Staff Summary Report

Development Review Commission Date: 01/22/08

SUBJECT: Hold a public hearing for a Use Permit and Development Plan Review for **WACHOVIA BANK** located at 915 E. Baseline Road.

COMMENTS: Request for **WACHOVIA BANK (PL070526)** consists of a one story financial building, with approximately 3,988 s.f., on .89 net acres, in the PCC-1 Planned Commercial Center Neighborhood, Zoning District. The request includes the following:

REVISION PLAN REVIEW:
 JANUARY 05, 2009
SITE PLAN
A-102

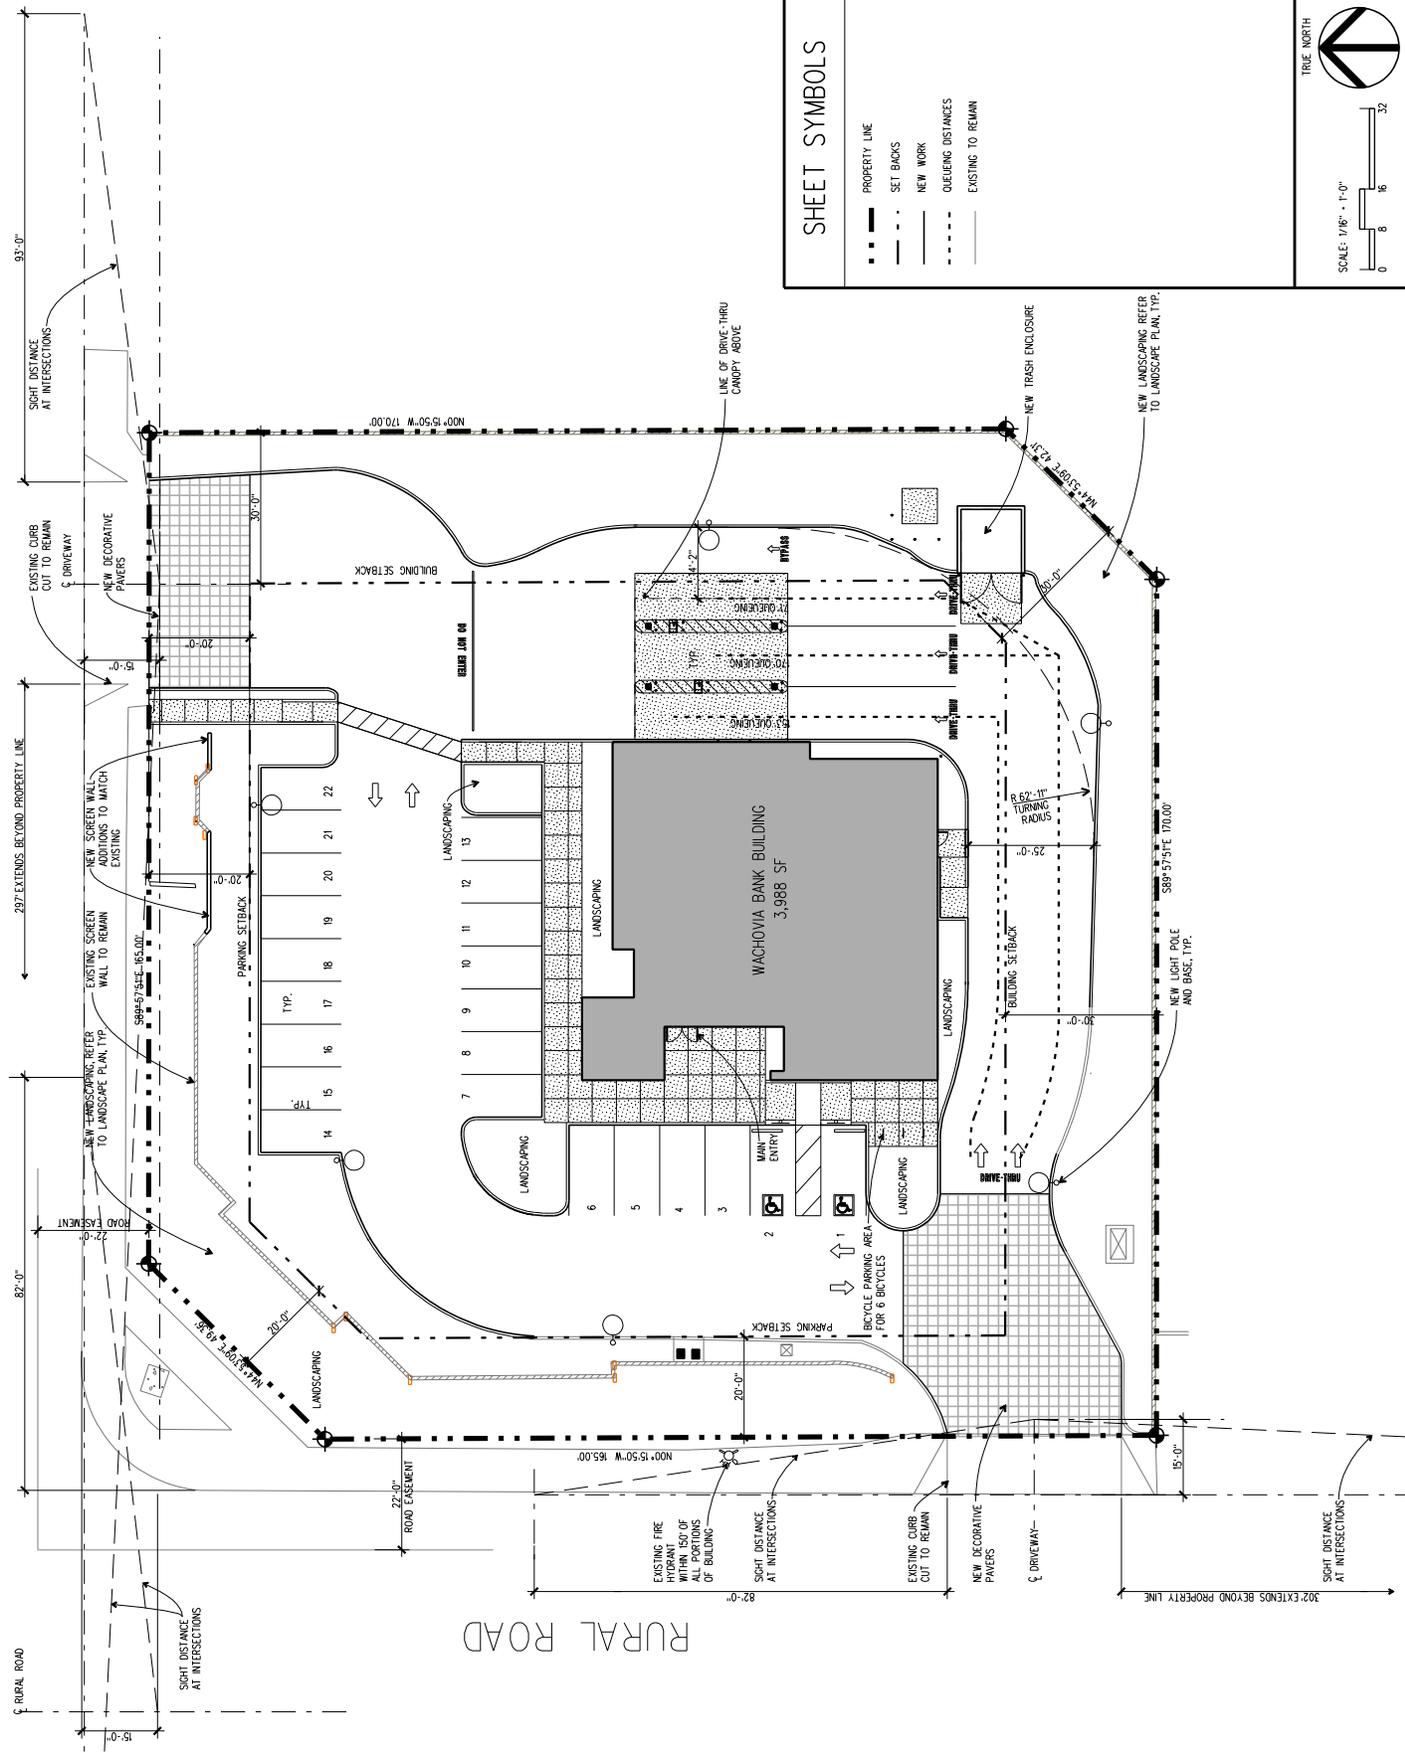
Site Plan

5. Provide 8'-0" wide public sidewalk along arterial roadways, or as required by Traffic Engineering Design Criteria and Standard Details.
6. Provide service yard and mechanical yard walls that are at least 8'-0" tall as measured from adjacent grade and are at least the height of the equipment being enclosed, whichever is greater. Verify height of equipment and mounting base to ensure that wall height is adequate to fully screen the equipment. Locate electrical service entrance sections inside the service yard, as indicated.

7. Provide upgraded paving at each driveway apron consisting of unit paving. Extend unit paving in the driveway from the back of the accessible public sidewalk bypass to 20'-0" on site and from curb to curb at the drive edges.

8. Utility equipment boxes for this development shall be finished in a neutral color (subject to utility provider approval) that compliments the coloring of the buildings.

PRELIMINARY LANDSCAPE PLAN

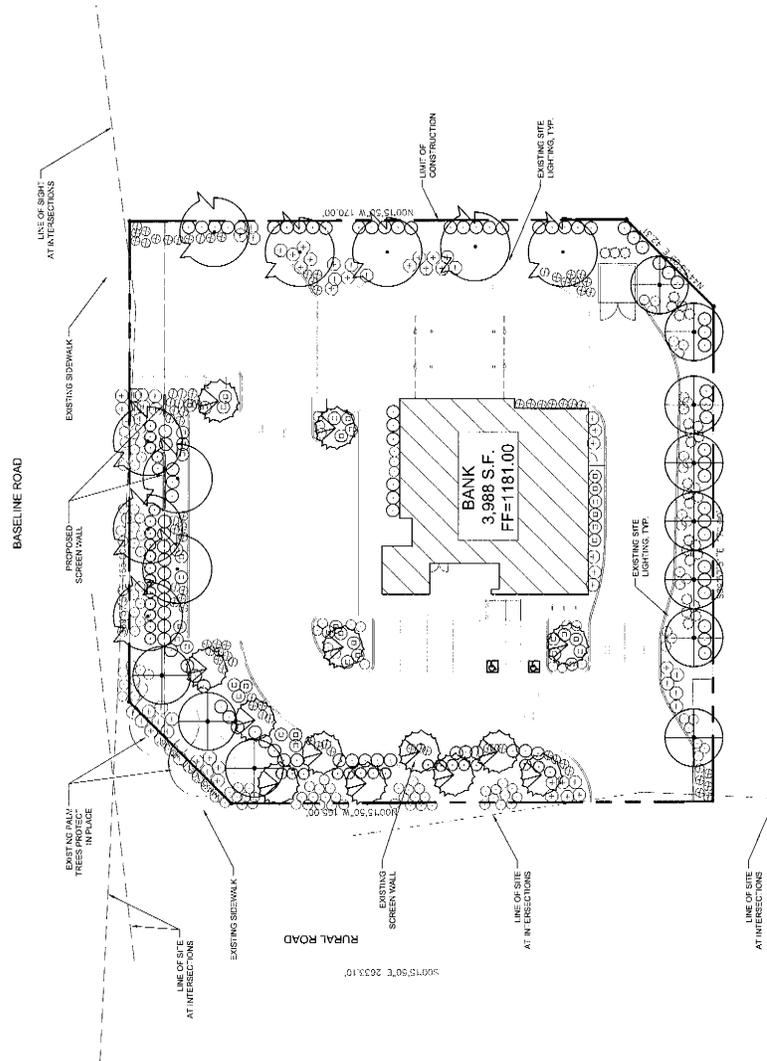
Landscape

16. The following plants are approved as proposed and specified:

Prunus cerasifera	Purple Plum	24" box
Olea europa 'Swan Hill'	Swan Hill Olive	24" box
Pinus brutia	Mondel Pine	48" box
Callistemon 'Little John'	Bottle Brush	1 gal.
Carissa macrocarpa 'Boxwood Beauty'	Natal Plum	5 gal.
Eremophila maculate 'Valentine'	Eremophila	5 gal.
Muhlenbergia capilaris 'Regal Mist'	Muhlenbergia	1 gal.
Landana montevidensis	Trailing Purple Lantana	1 gal.
Lantana 'New Gold'	New Gold Lantana	1 gal.
Ruellia brittoniana 'Katie'	Katie Ruellia	1 gal.
Decomposed Granite	Gold	¾" minus

Submit any additions or modifications for review during building plan check process. Planning inspection staff will field verify plants.

17. Irrigation notes:

18. Include requirement in site landscape work to de-compact soil in planting areas on site and in public right of way and remove construction debris from planting areas prior to landscape installation.

19. Top dress planting areas with a rock or decomposed granite application. Provide rock or decomposed granite of 2" uniform thickness or less. Provide pre-emergence weed control application and do not underlay rock or decomposed granite application with plastic.
